**BILLYARD AVE DEVELOPMENTS PTY LTD ATF BILLYARD AVENUE DEVELOPMENT TRUST V  
CITY OF SYDNEY COUNCIL**

**21C Billyard Avenue, ELIZABETH BAY**

**SUPPLEMENTARY JOINT EXPERT REPORT ADDRESSING HEIGHT OF BUILDINGS  
CALCULATION**

Supplementary Joint Expert Report  
Appendix B: Height Plane Amendment

# Amended Height Plane - Section Diagram (DA010 F)

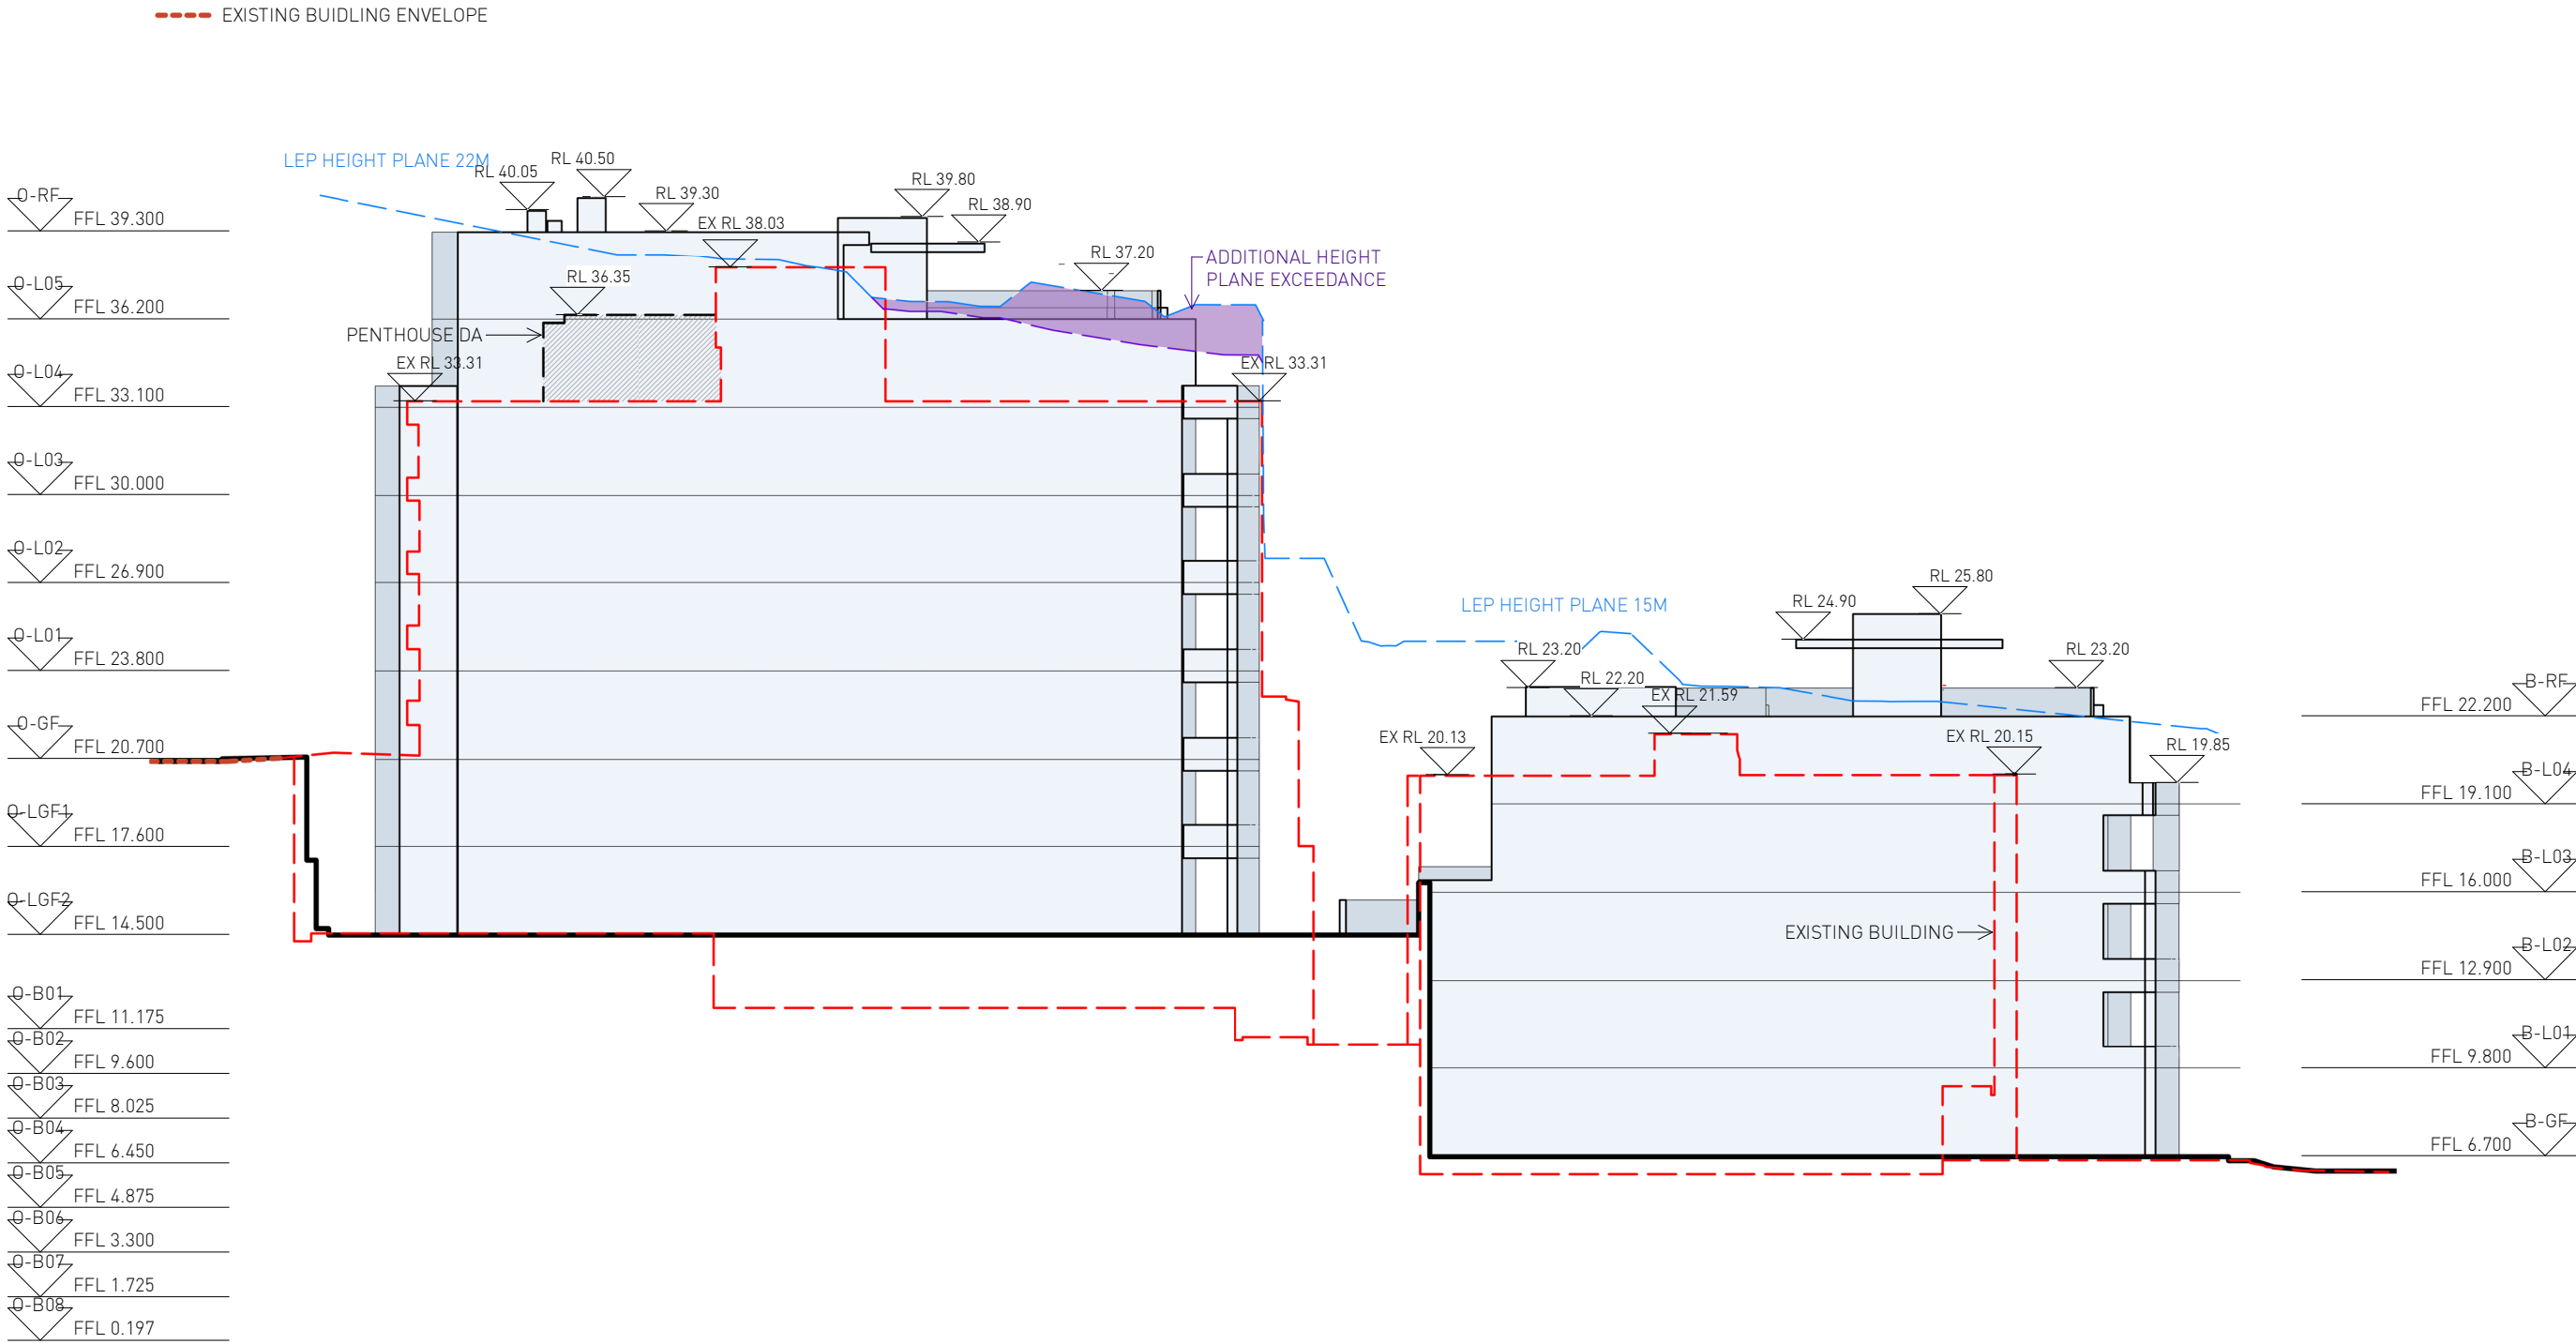
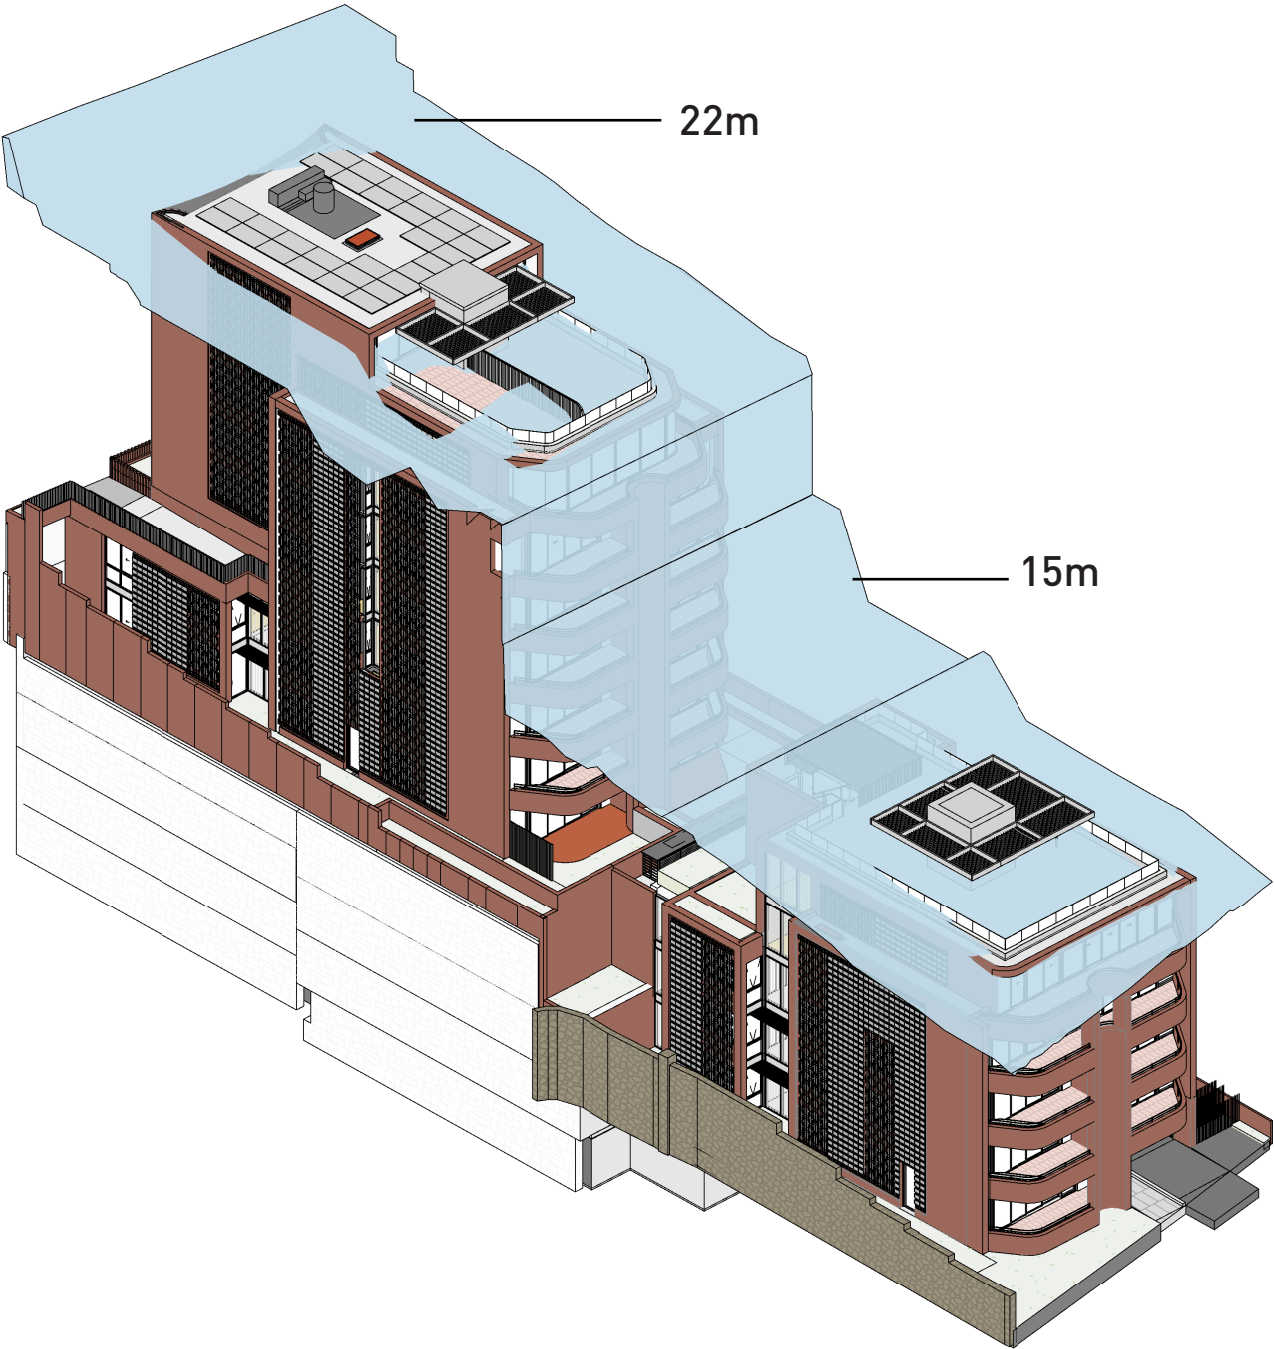
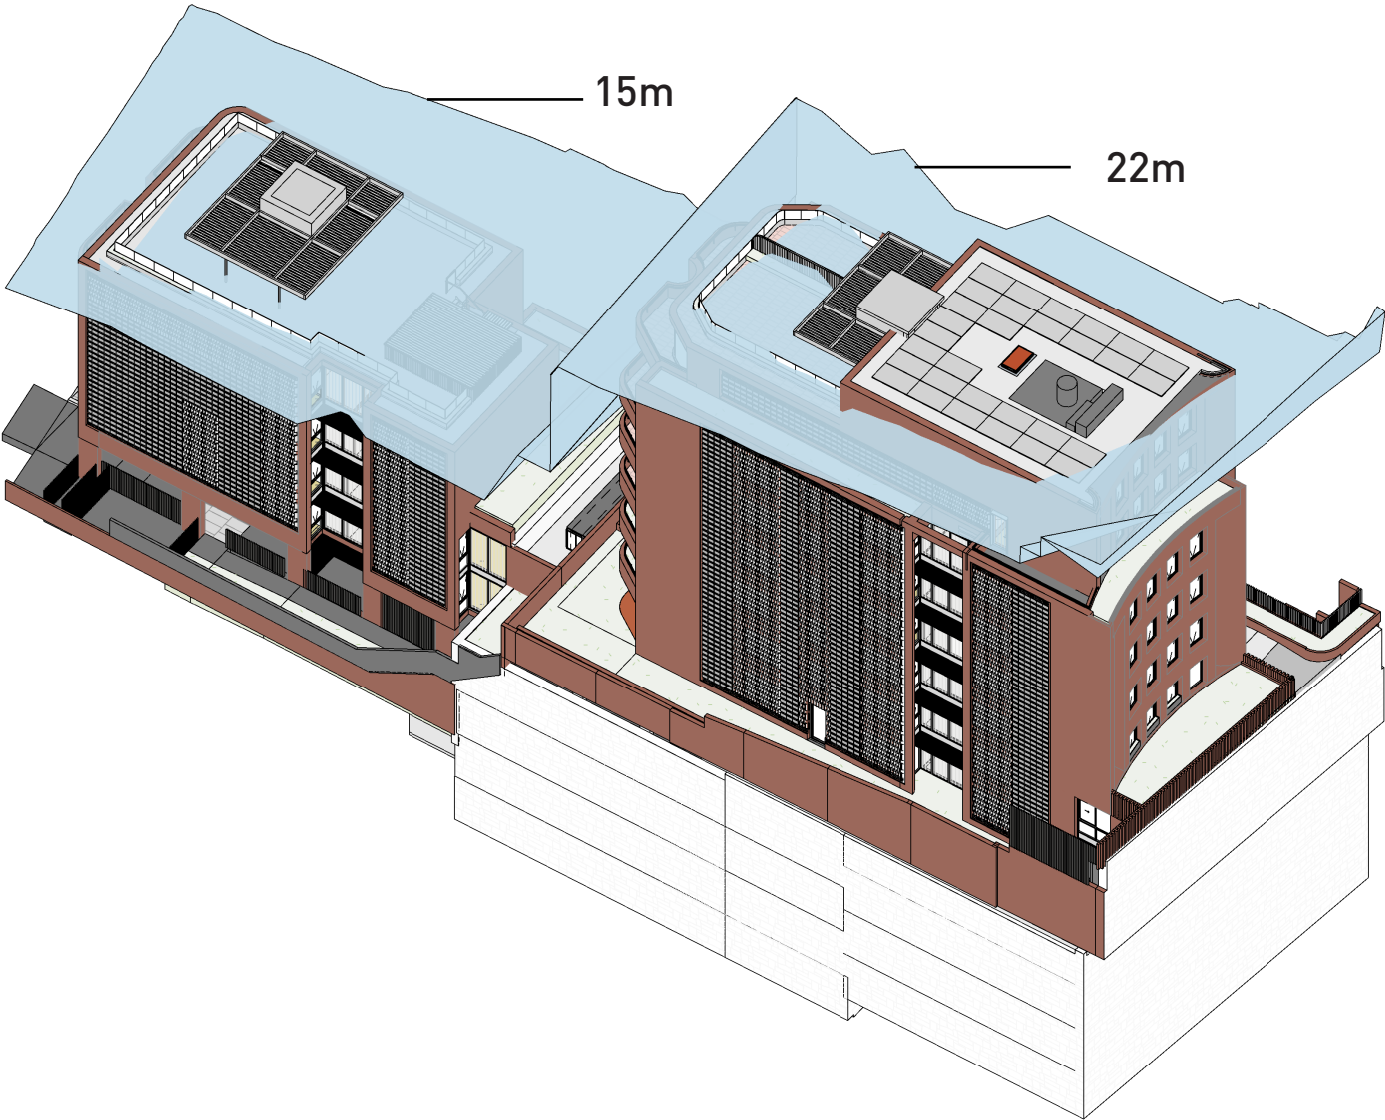
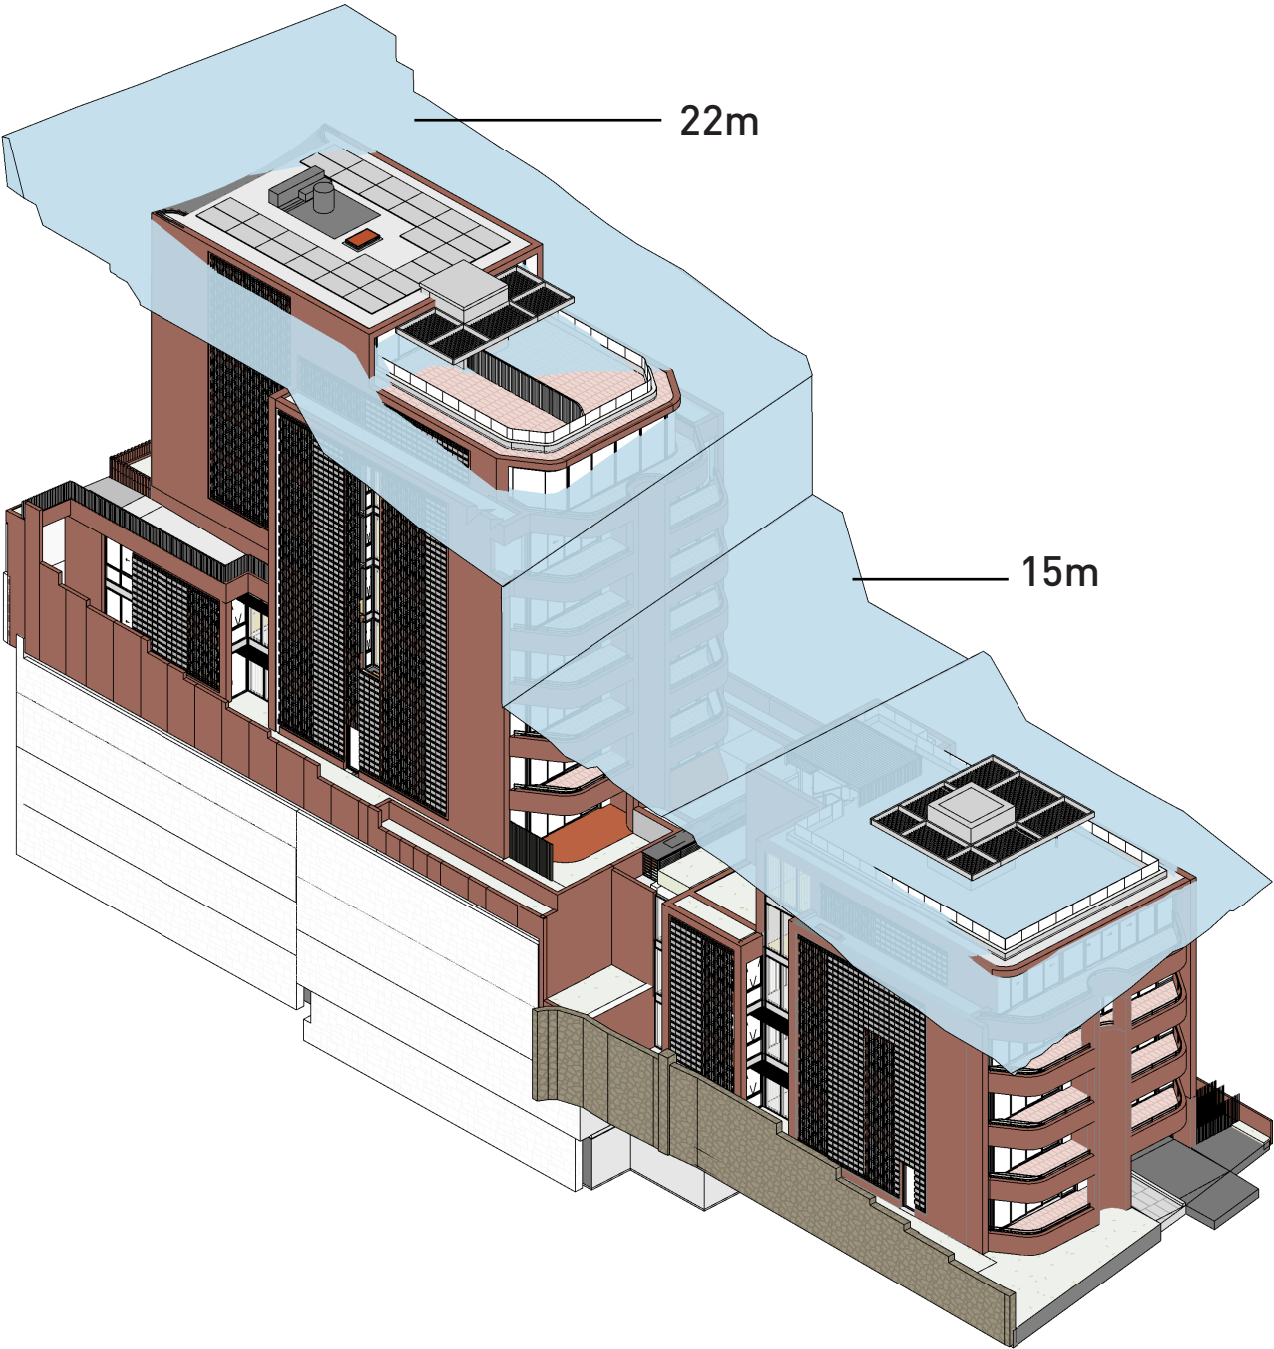
Current: DA Issue 09

Amended
